Comment Letter 1236

Subject: DEIR Public Comments regarding feasibility of proposed Direct and Cumulative Traffic mitigation claims for Newland Sierra General Plan Amendment and Specific Plan PDS2015-GPA-15-001 (GPA), PDS2015-SP-15-001 (SP).

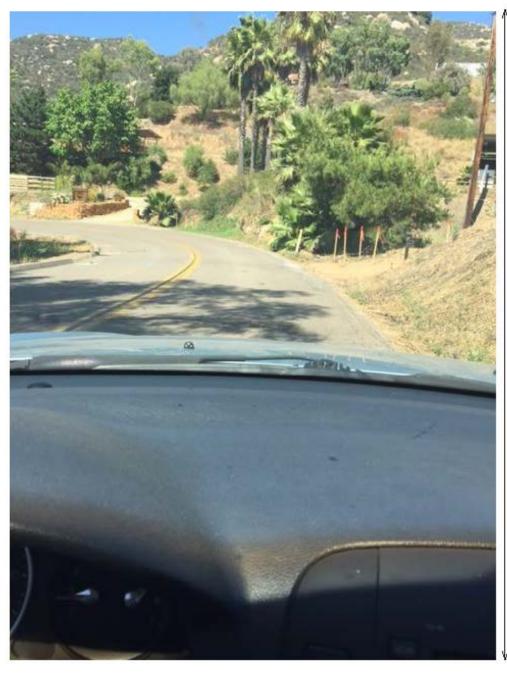
- Pix #1 is a sign past Twin Oaks Crest Dr. showing 2 miles of hairpin turns when traveling on TOVR descending into the valley
- 2. Pix #2 is just past the sign showing one of the TOVR descending curves

- 3. Pix #3 is CM as it is today, a private unpaved road intersecting with TOVR which is .2 miles from the sign in Pix #1
- Pix #4 is a typical rock quarry truck driving south, ascending the TOVR curve section about .2 miles the other side of CM & TOVR intersection

- 5. Pix #5 is quarry truck ascending, wheels over the line
- 6. Pix #6 is quarry truck ascending, needing to swing wide in hairpin curve with wheels over the line

- 7. Pix #7 is quarry truck back end ascending, wheels over the line for next curve
- Pix #8 is quarry trucks side by side, zoom in to view front end of quarry truck ascending while 2nd quarry truck back end (yellow body) is descending

- 9. Pix #9 is bicyclist in middle of road, quite typical to see.
